PC17 HAUTAPU INDUSTRIAL
Transportation Review, Assessment and
Recommendations

22 February 2023

Prepared for:
Waipā District Council

Prepared by:
Stantec

Figure 2: Proposed Hautapu Industrial Structure Plan (as notified)

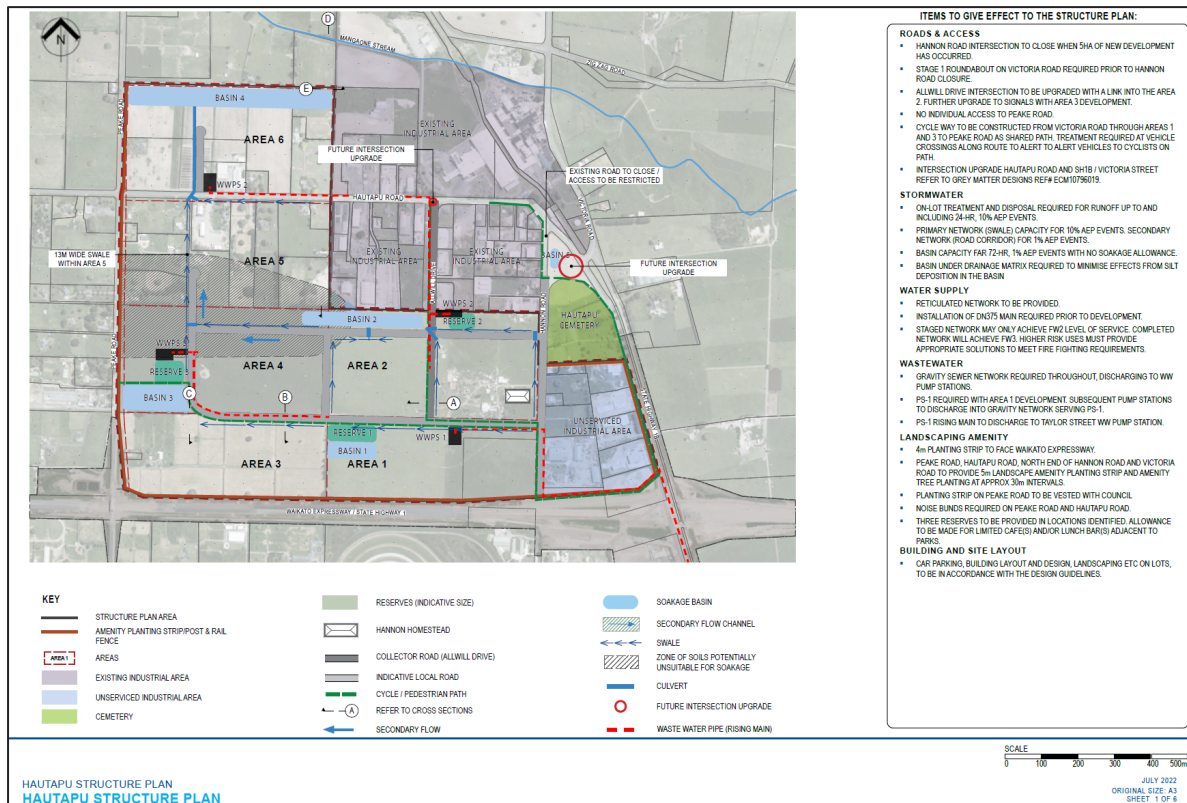
Review of the background material, including the proposed structure plan (the notified version) and transportation submissions and further submissions (refer to Section 7), has however identified the following matters as requiring further consideration and assessment:

- Confirmation of the staging and timing of the planned transportation infrastructure projects with the inclusion of “Area 6”. With “Area 6” identified in the Future Proof Strategy 2022 (refer to Section 4.1) as earmarked for short-term industrial development, development of the site can be expected to bring forward planned improvement projects such as the urbanisation works on Hautapu Road.

- Further identification of walking and cycling linkages within the structure plan area, and with the wider walking / cycling network. A review of the proposed structure plan (the notified version) identified some areas where walking and cycling connectivity could be improved to achieve a well-integrated multi-modal transport outcome more effectively.

- Future public transport servicing for the structure plan area and the wider Hautapu industrial area. While the Hautapu area is currently not serviced by public transport, the industrial node is identified in the Future Proof Strategy 2022 (refer to Section 4.1) as a future local node.

These matters are assessed in Section 6 of this report. Section 6 also details recommended amendments to the structure plan in response to some of these matters.

Figure 5: Configuration assessed in the HG ITA for the future Victoria Road/ Hautapu Road roundabout

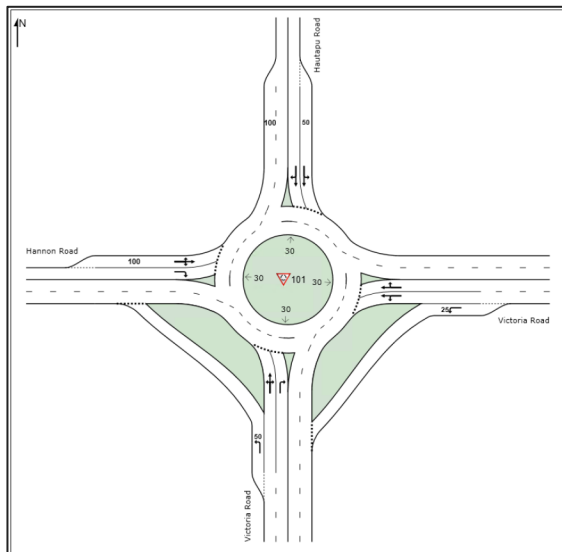
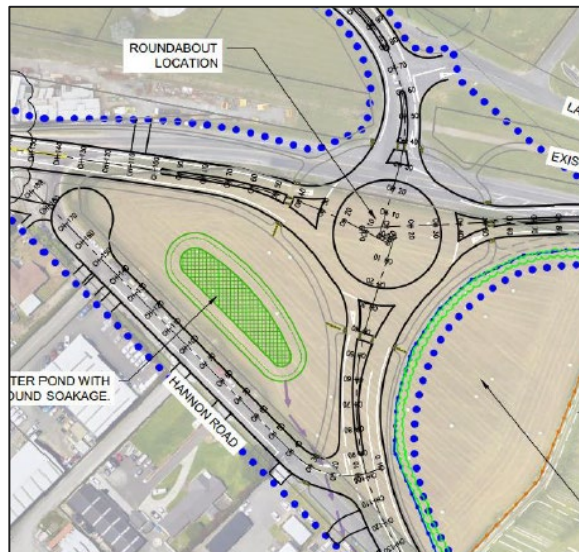
- The assessment noted that the earlier HG report evaluated the future Victoria Rd / Hautapu Road intersection as a dual-lane configuration (with additional left-turn slip lanes for the southern and eastern approaches), but through consultation with Council, a single-lane roundabout design was now being advanced for the intersection in the interim to support wider mode shift outcomes. The referenced designs are illustrated in Figure 5 and Figure 6 below.

Figure 9: Proposed Amendments to the Proposed Hautapu Industrial Structure Plan

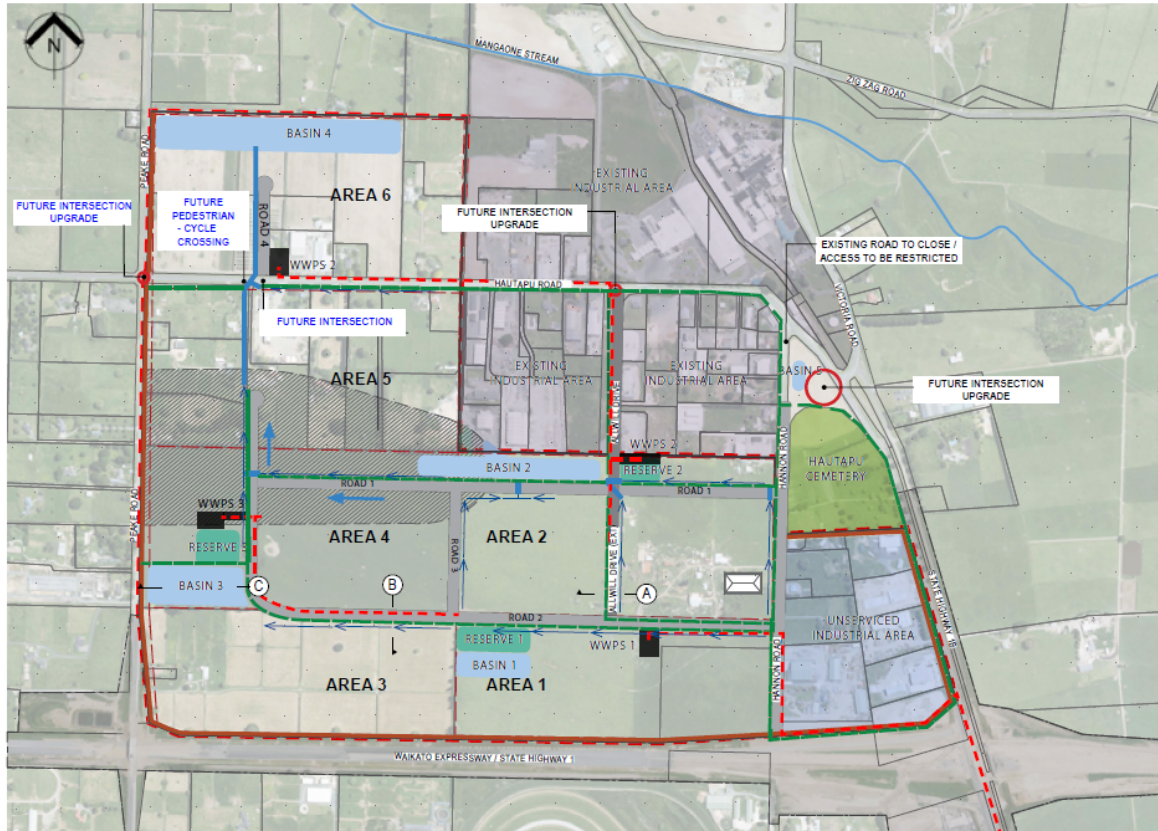
These measures will enhance the overall safety and integration of the structure plan. They are shown on the attached and updated structure plan included as Figure 9 (refer to section 6.5 as follows below).

Based on the assessments and infrastructure triggers described above, amendments are proposed to the structure plan as shown on Figure 9 (refer to **Appendix A** for an enlarged version of the structure plan amendments) that follows:

These specific infrastructure triggers are proposed to provide greater assurance as to the timing of infrastructure in relation to land development demand and have been demonstrated to provide the necessary transport corridor capacity and local safety outcomes necessary.
